ARCHITECTURAL DRAWINGS

84 - 88 BIRRIGA ROAD
BELLEVUE HILL, NSW, 2023

PROPOSED NEW APARTMENT DEVELOPMENT OVER 2 BUILDINGS SET ON 2 ADJACENT LOTS,
INCLUDING 16 NEW APARTMENTS AND ASSOCIATED LANDSCAPING WORKS

2 DEVELOPMENT APPLICATION

PROPOSED EGRESS PATH - LOOKING WEST

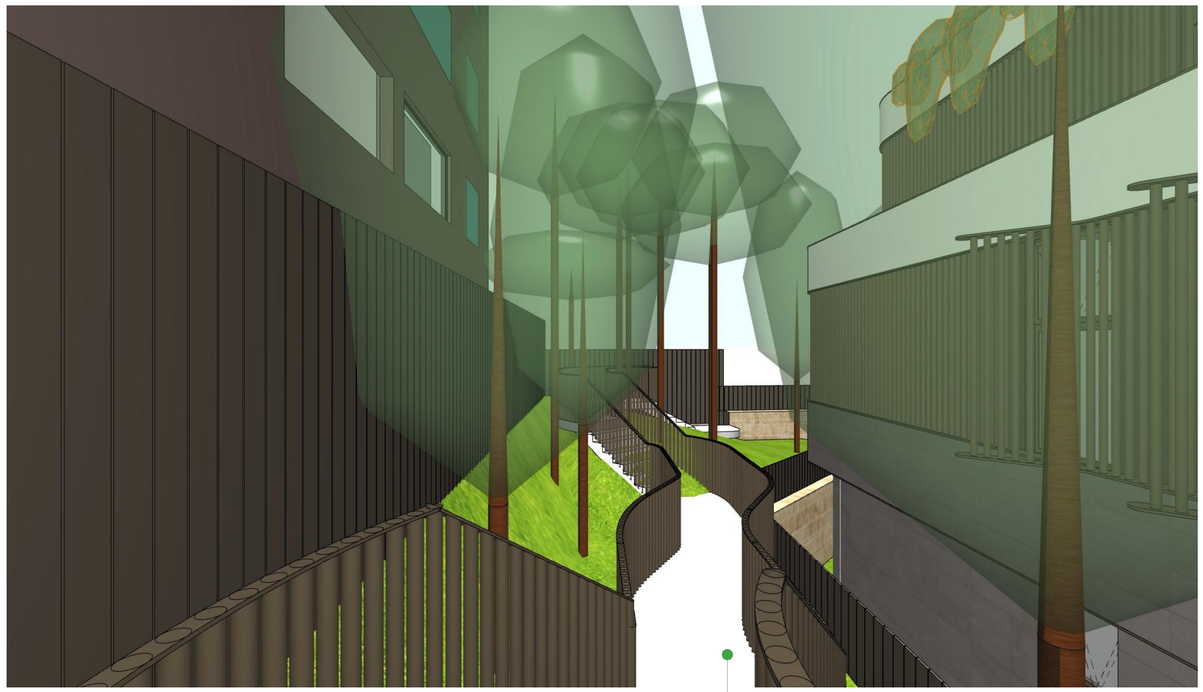
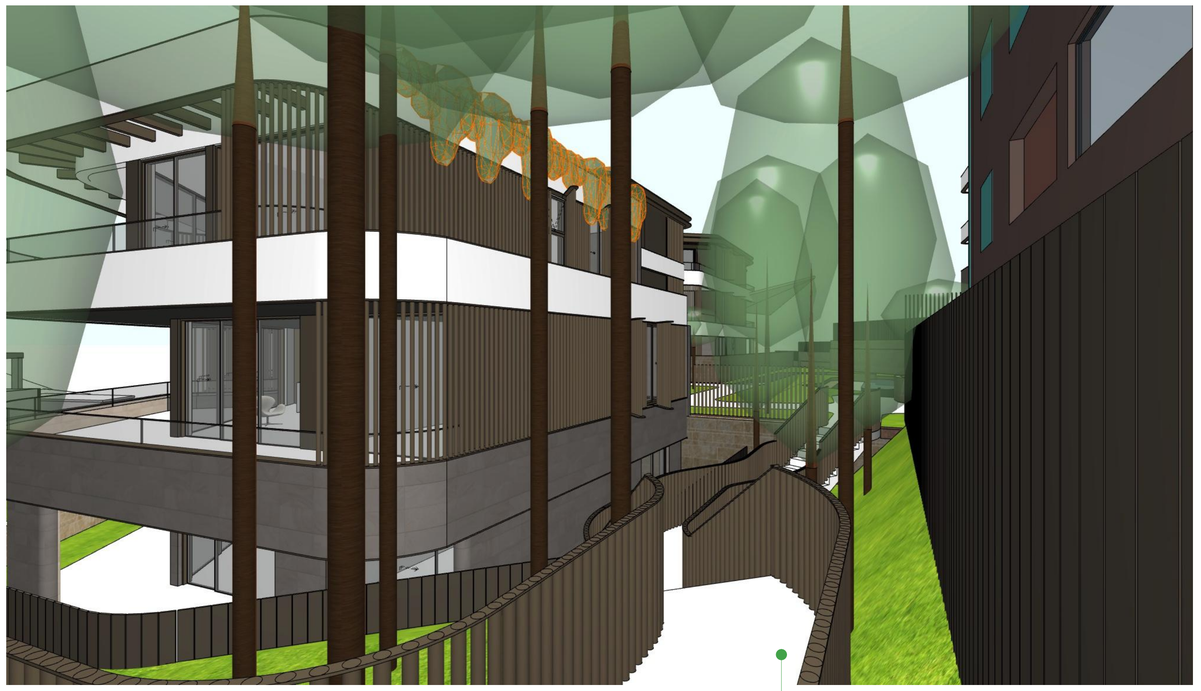
1. EGRESS PATH AMENDED (LOWERED). RETAINING WALL RELOCATED TO INCREASE SEPERATION TO EXISTING TREE

PROPOSED EGRESS PATH - AERIAL - LOOKING WEST

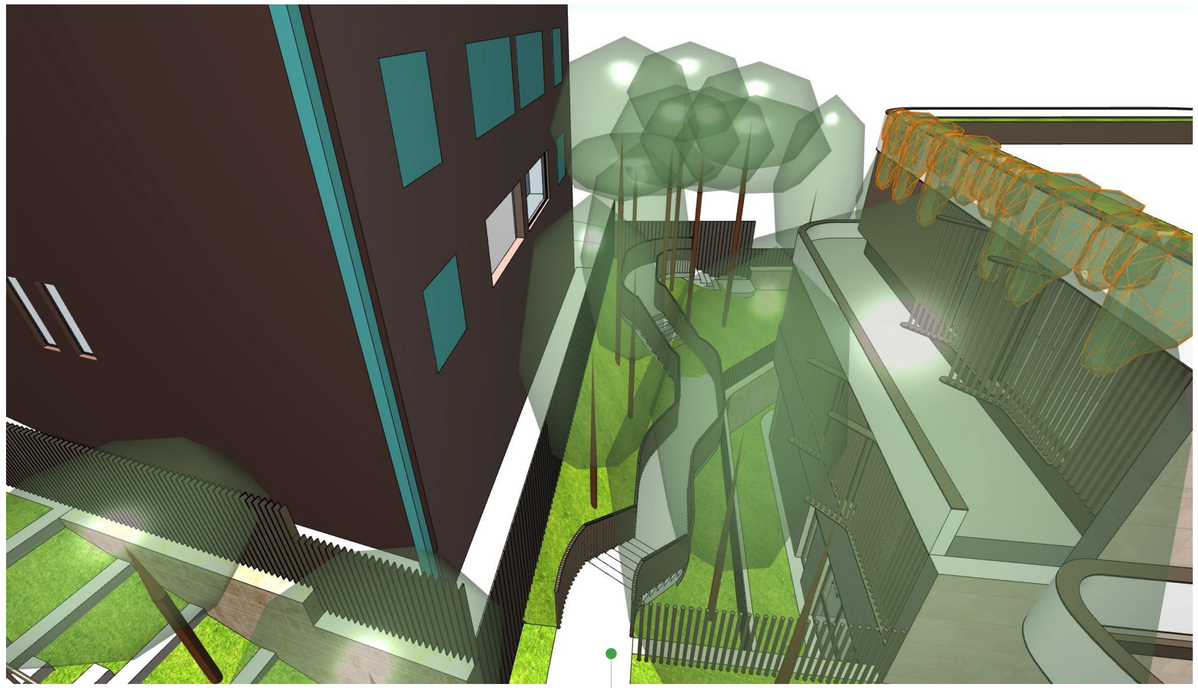
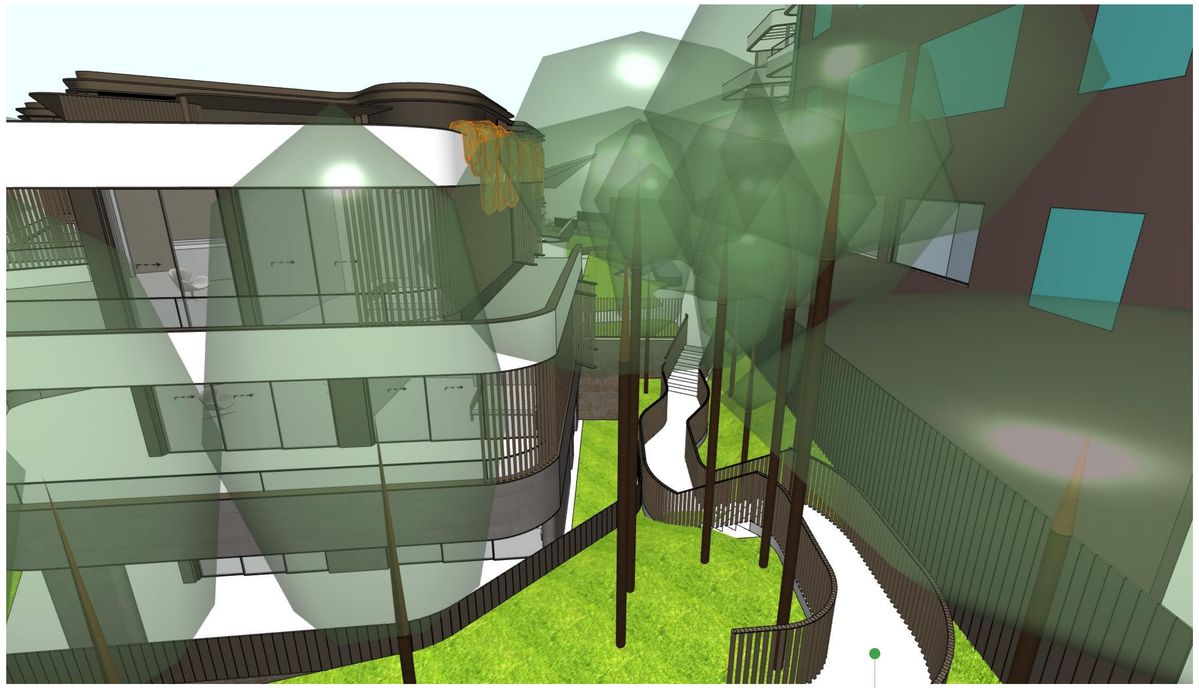
1. EGRESS PATH AMENDED (LOWERED). RETAINING WALL RELOCATED TO INCREASE SEPERATION TO EXISTING TREE

VIEW OF BUILDING B FROM #82 BIRRIGA ROAD UNIT 1

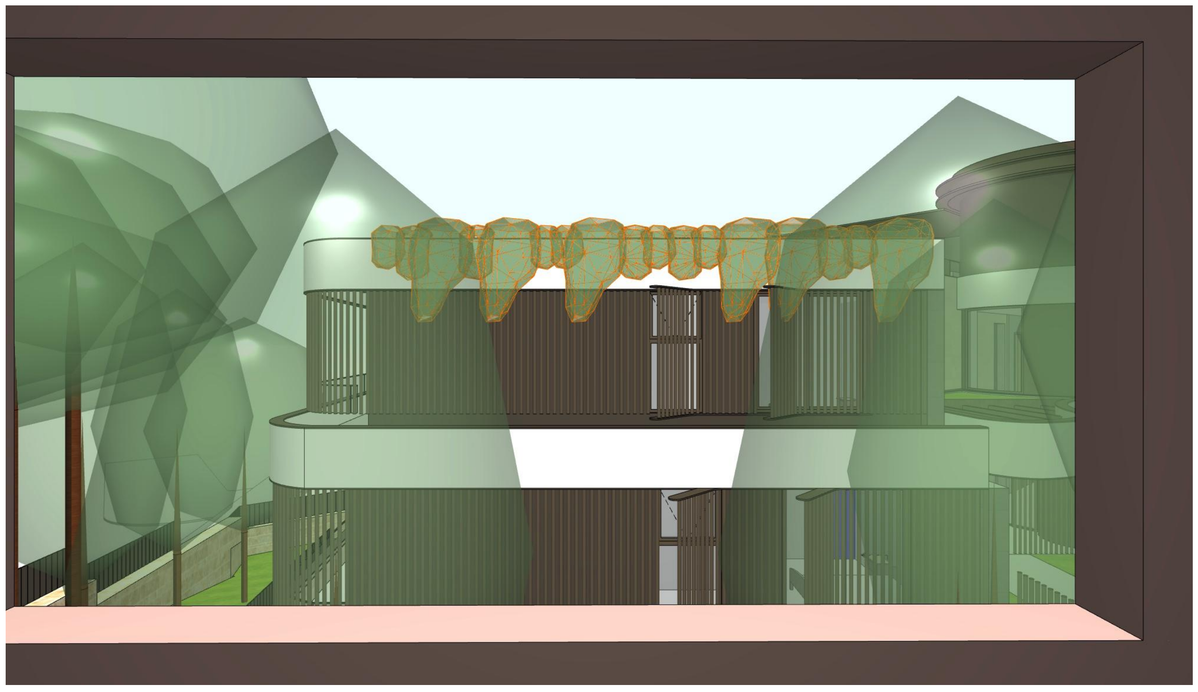
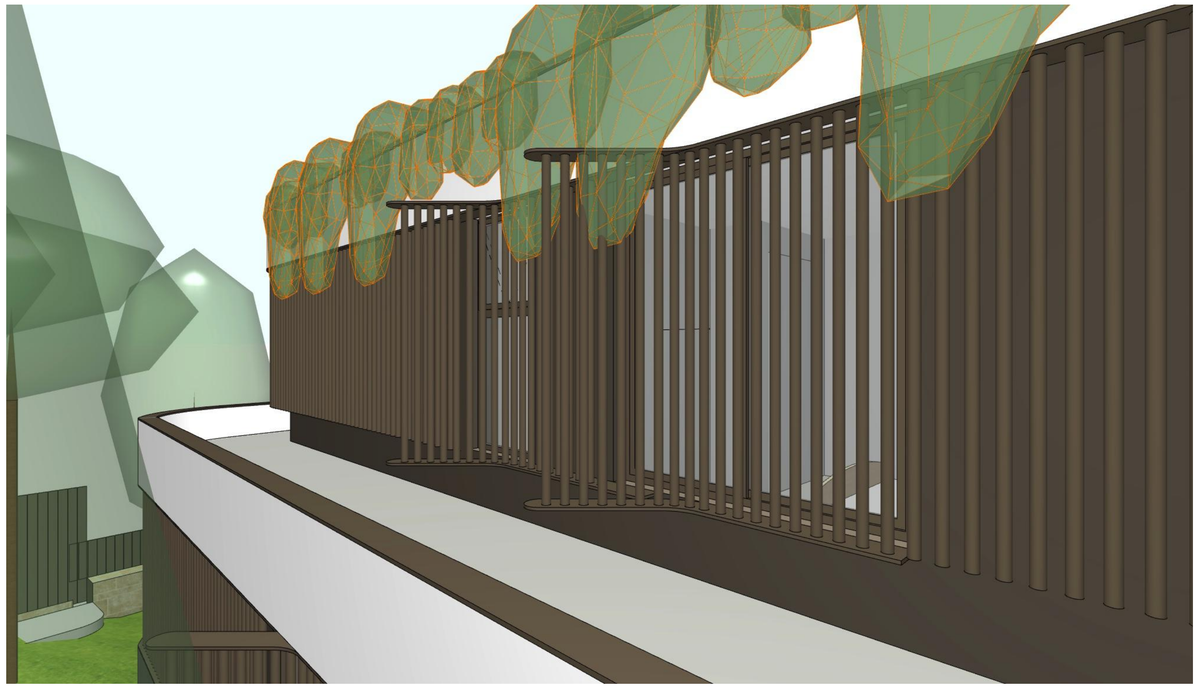
1. EGRESS PATH AMENDED (LOWERED). RETAINING WALL RELOCATED TO INCREASE SEPERATION TO EXISTING TREE **- REFER TO PREVIOUS DRAWINGS FOR LOCATION**
